STAFF REPORT 12-14-2022 REGULAR MEETING

APPLICATION NUMBER: 22-8150

ADDRESS: 84 EDMUND PLACE

SCOPE: ERECT NEW MULTI-FAMILY BUILDINGS

From applicant's submission: Frontage elevation showing context.

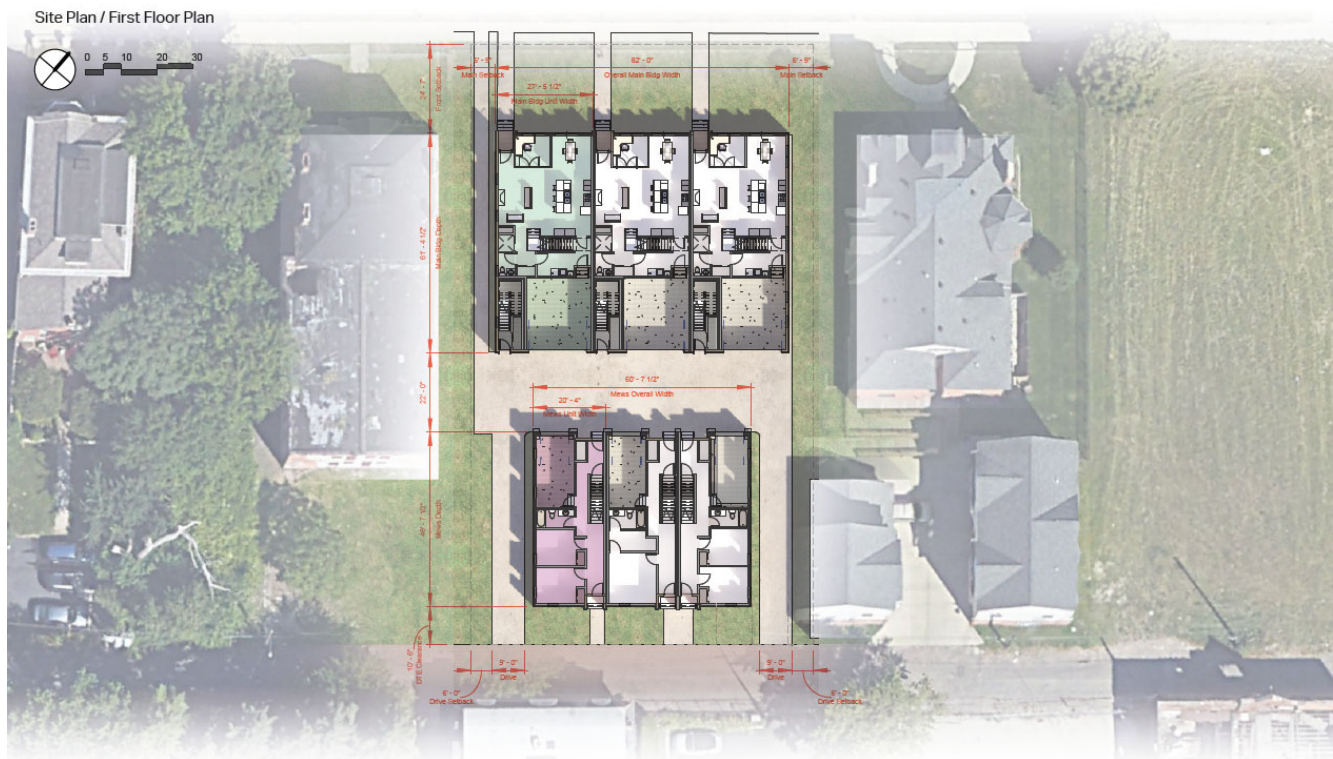
- However, consistent with the design review report provided by PDD (accompanying this historic staff report), in our opinion the *non-primary elevations* (sides and inward-facing rear facades of each building) lack adequate texture and articulation, and seem flat and disconnected from the main facades. Elements of Design 3, 7, 8, and 10 as described above are lacking. While these exposures would not have to be as well-developed as the primary facades, certain textures, shadow lines and other elements present at the front should be carried around to the sides and rear, consistent with historic prototypes. There may be a number of different ways to accomplish this in a modern spirit, including the addition of materials and detailing present on the main facades, more deliberate recess and framing of window openings, adding additional paired openings, etc.

- The non-primary elevations need to be further developed.
- Material and product selection for doors, windows, railings, and other exterior elements should be provided in a subsequent revision.

- The design be further developed at the non-primary elevations consistent with input from PDD Design Review and Historic staff. Upon receipt of an updated design, staff may approve the revisions for permit if consistent with the Elements of Design and the Secretary of the Interior's Standards, or return the design to the Commission for further review if necessary.
- Product selections for exterior elements including but not limited to doors, windows, and railings be provided for staff review.
